Thank you for contacting the City of Sammamish regarding the current Shoreline Substantial Development Permit Application for East Lake Sammamish Trail Segment 2B (SSDP2016-00415).

Exhibit 29
SSDP2016-00415
003261

Review of Sammamish Trail Plans Near Location 457

Exhibit 1

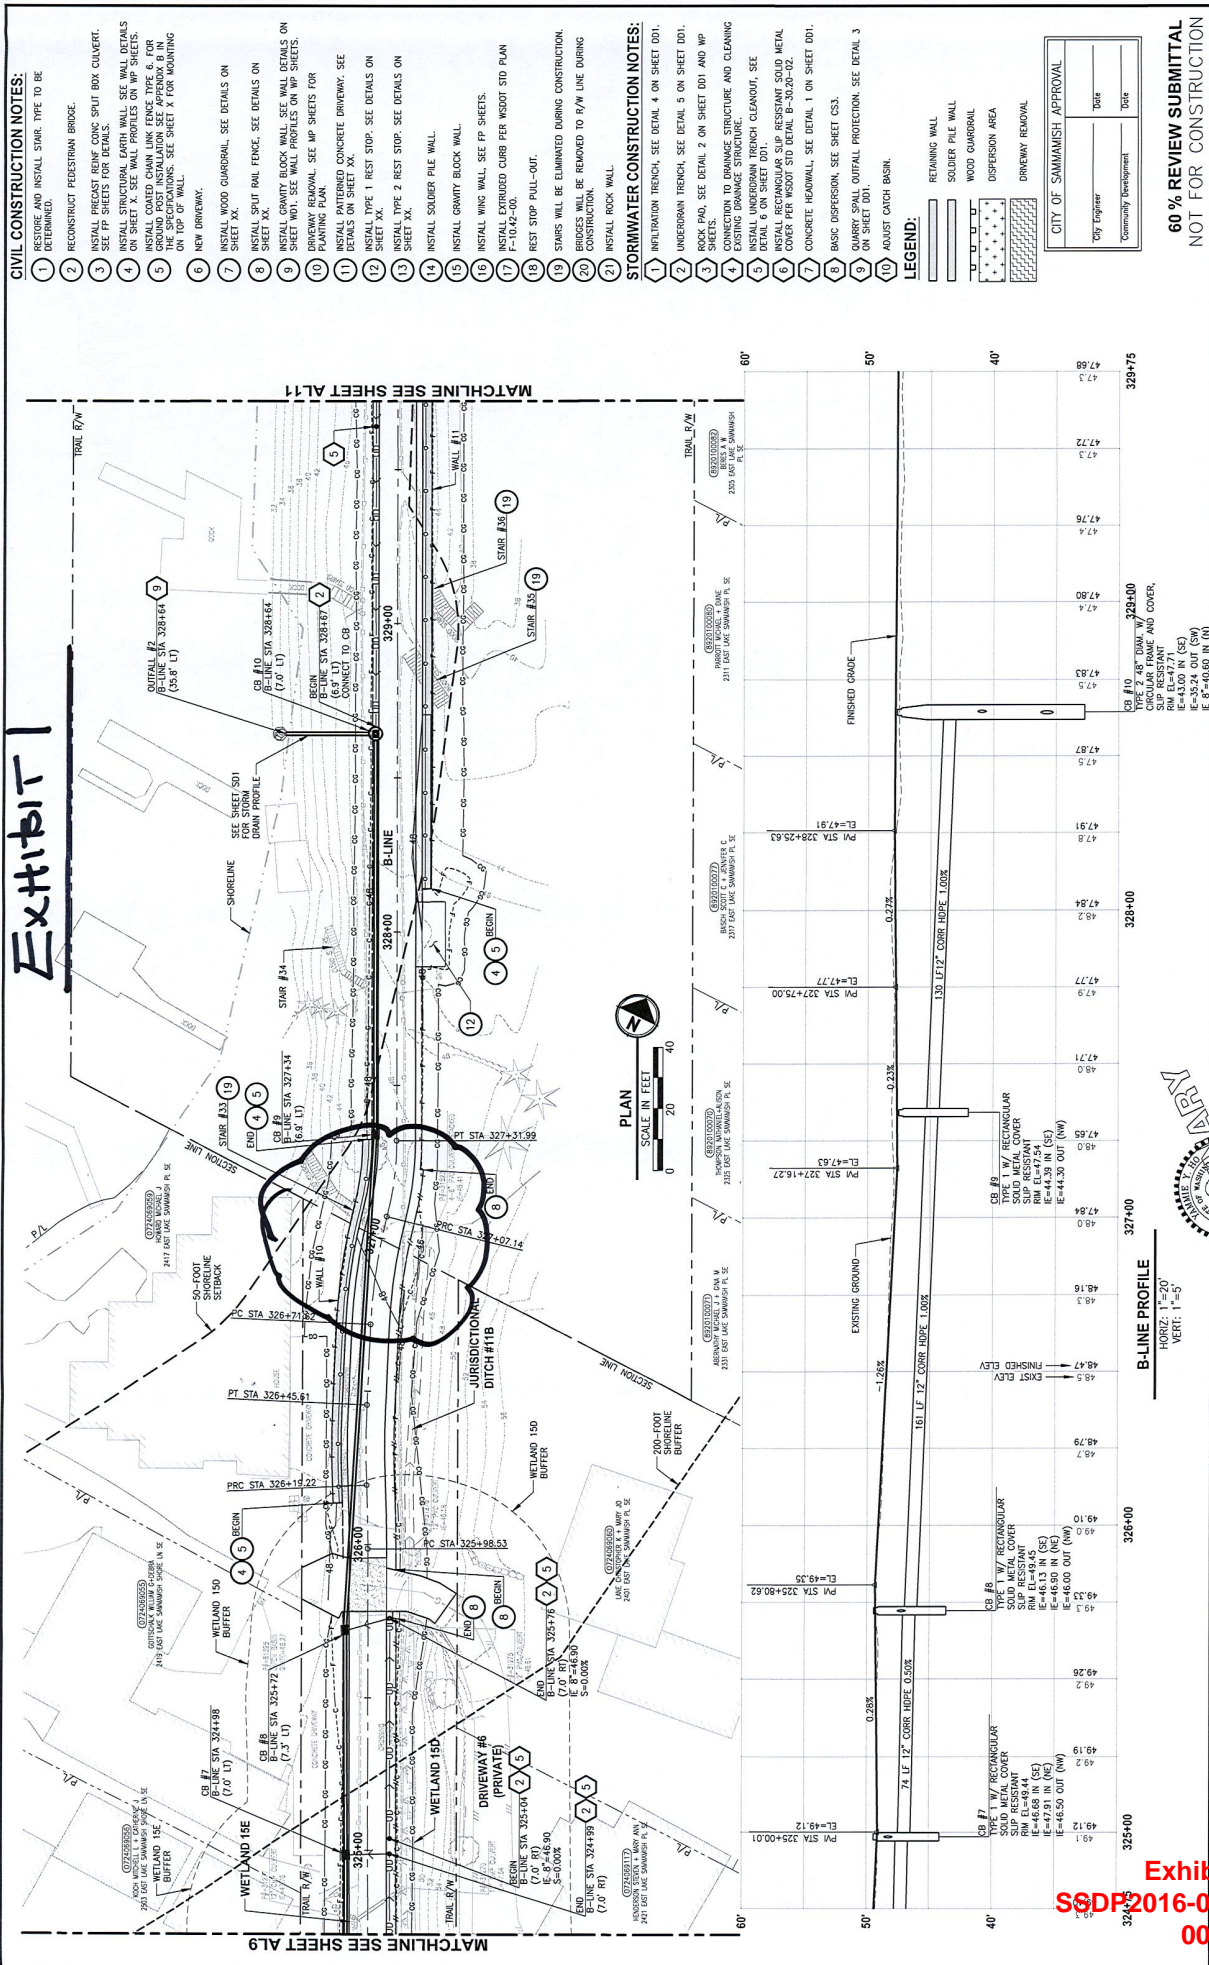
- **Clearing and Grubbing Limits** – My clients also propose that the clearing and grubbing lines be modified to correspond to my clients' preferred Trail realignment. My clients' proposed modifications are depicted on the attached Exhibit 3. Further, the clearing limits should be adjusted to follow the course of the Trail in order to prevent and/or limit, any adverse impacts to my clients' existing stamped concrete driveway, irrigation, drainage, and landscape lighting.
